SAN GORGONIO CHAPTER

Moreno Valley/Box Springs Group

RE: Item 4.1-1: RIV090903 - Cajalco Road Widening and Safety Enhancement Project – SCH #2011091015;

Thank you for the opportunity to provide comments on the Review of PM Hot Spot Analysis Interagency Review Form on the Cajalco Road Widening Project: SCH # 2011091015 – RIV090903. The Cajalco Project is a proposed expansion of a 2-lane road in Western Riverside County for 15.7 miles between I-15 and I-215.

Figure 1. Future project locations from RCTC Long-Range Transportation Study (2019). The alignment of the Cajalco Road project is the location of the CETAP state highway ID: 3C01MA01 – project 1 in Appendix A.

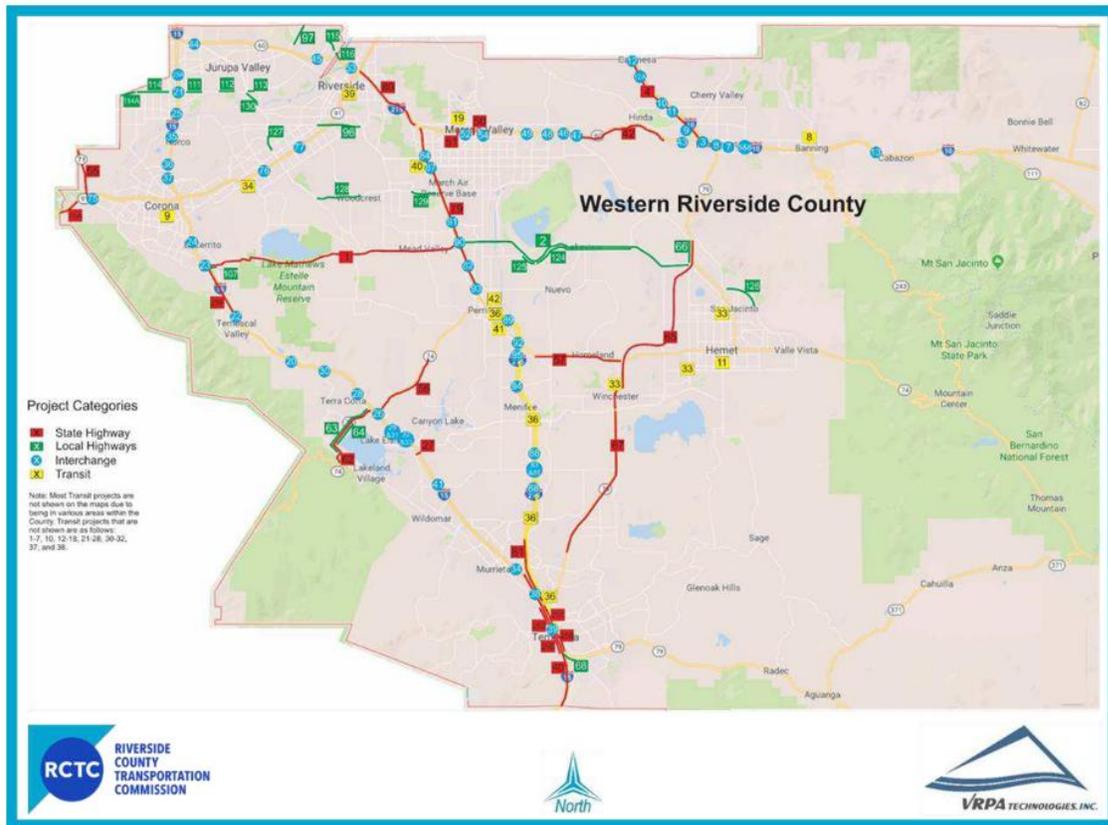
Figure 1 (red line – project 1) shows the alignment of the CETAP east-west highway from the RCTC 2019 Long Range Transportation Study. The CETAP alignment is identical to the proposed Alternative 1 from the Cajalco road widening project; it is NOT a separate parallel facility. It is the long-term 6-lane state highway version of the current proposed 4-lane project. There are no other long-term projects shown in the long-term strategic plan that are a separate parallel facility. **Figure 2** shows the adopted Riverside County Circulation Element (2020) for existing and planned corridors in western Riverside County. There is no parallel expressway or arterial to Cajalco Road between Lake Mathews and Highway 74.

The traffic analysis for the project DEIR and the conformity analysis is therefore **double-counting** the Cajalco road widening and CETAP facility as separate projects and is drastically underestimating future traffic volumes. Please revise the traffic analysis for this project that double counts traffic volumes using inaccurate RIVCOM model inputs. All traffic analysis that includes the ‘CETAP corridor analysis’ is invalid. Only the ‘Without CETAP corridor’ analysis is possible, with the corresponding higher traffic volumes as shown in **Table 3.6-16** from the DEIR; these traffic volumes and Level-of-Service ratings are significantly higher and more congested than those identified in Tables 2 and 5 in the TCWG Project summary. Truck volumes will increase by between 80-350% along the new route with thousands of extra truck trips daily.

Figure 2. A screenshot of Figure C-1 from Riverside County General Plan (2020) Circulation Element zoomed into Western Riverside County.

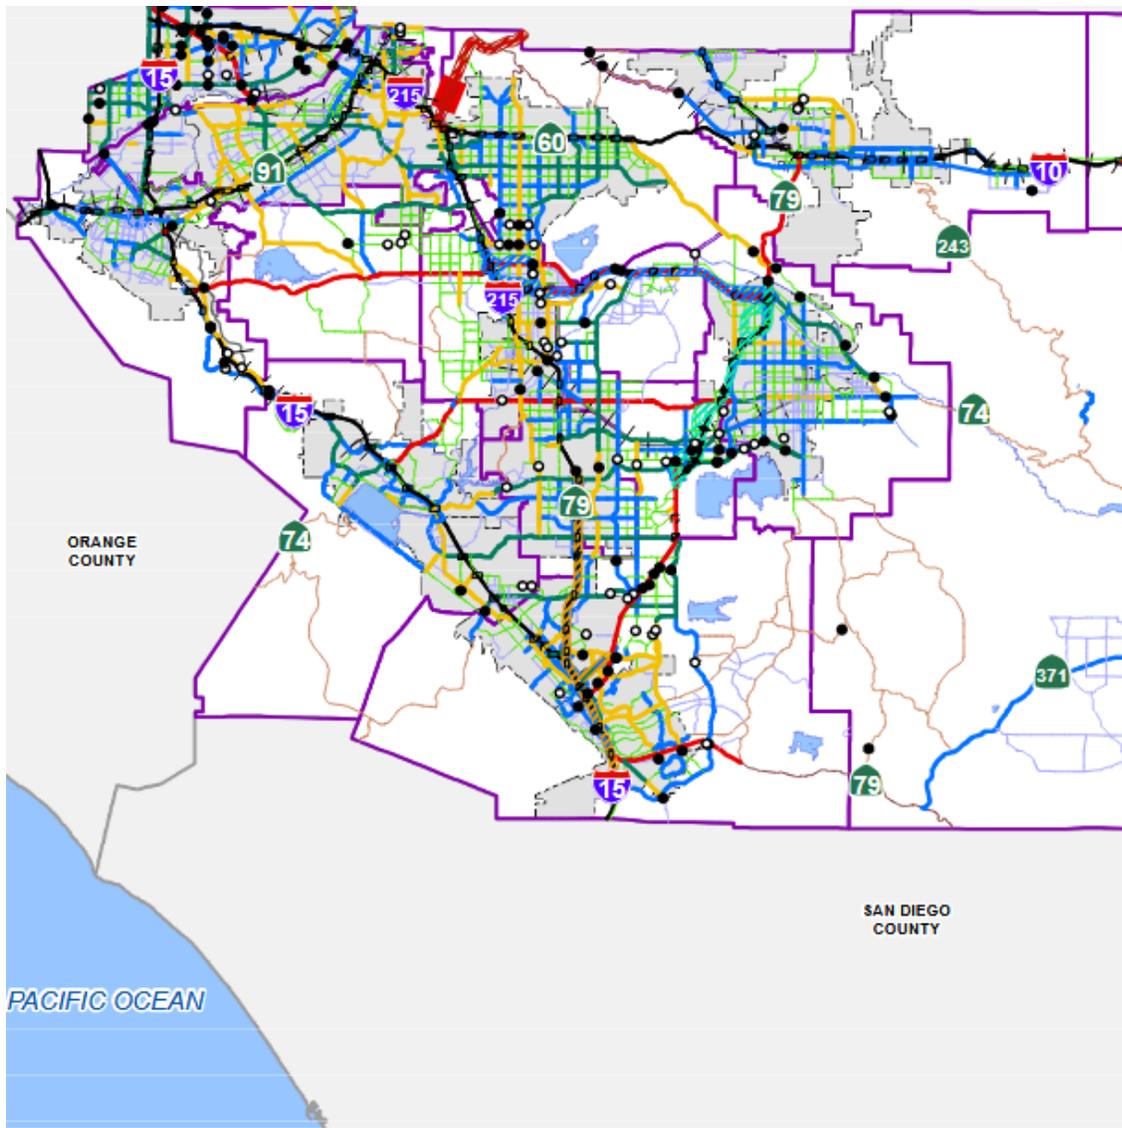
The Hemet to Corona/Lake Elsinore corridor was refocused by RCTC in 2009 to actively study and design alignments connecting Interstate 215 easterly to State Highway 79. The refocused alignment is also called the Mid County Parkway. Figure C-1 has been updated to reflect the alignments under study for the Mid County Parkway. As part of the refocusing action, RCTC removed from consideration all alignments within the westerly portion of the Hemet to Corona/Lake Elsinore corridor connecting Interstate 215 to Interstate 15 and this portion of the corridor is not being actively studied as of 2011. Nonetheless, the westerly portion of the Hemet to Corona/Lake Elsinore Corridor is still anticipated to be needed in the future and has been retained by RCTC in its Regional Transportation Plan for the area generally bounded by Lake Mathews and the City of Riverside to the north and State Highway 74 to the south so that future east/west transportation improvements connecting Interstate 215 and Interstate 15 are not precluded.

Figure 3. Warehouse projects and industrial rezones within a few miles of the eastern terminus of the Cajalco project. Data on Foundation General Plan Amendments from Planning Department.⁷

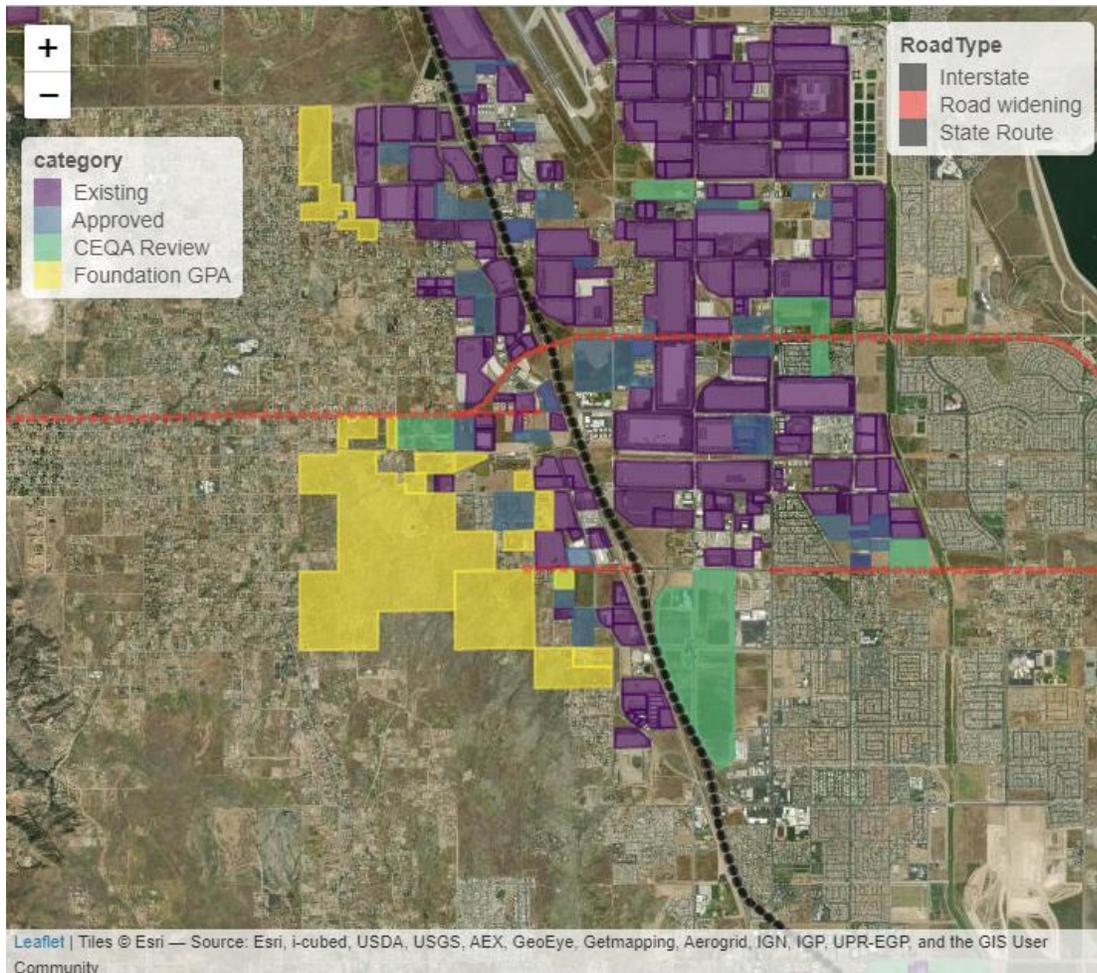
- 1) Warehouse growth on the eastern terminus of the project has more than doubled the footprint of warehouses within 3 miles of the Cajalco-215 on-ramp from ~36M SQ FT in 2014 to over 79M SQ FT in 2025⁵. This has more than doubled truck volumes on I-215.
- 2) Significant additional warehouse growth is planned on the eastern terminus of the project, at least partially because of the long-planned Cajalco roadway expansion. **Figure 3** shows existing, approved, under CEQA review, and under County pre-review projects along the Cajalco – I-215 terminus. Thousands of acres of land are being rezoned from residential to industrial along this roadway and the adjacent Mid County Parkway. A reasonable list of projects to include that are ‘cumulatively considerable’ and ‘reasonably foreseeable’ within 2 miles of the project include:
 - a. Harvest Landing (SCH# 2024080337) – 288 acres of warehouses

In total, the failure to account for land-use changes over the last 10 years and the ongoing rezoning of land-use along this corridor, along with the underestimated truck volumes on major endpoints is resulting in complete failure to accurately project truck volumes.
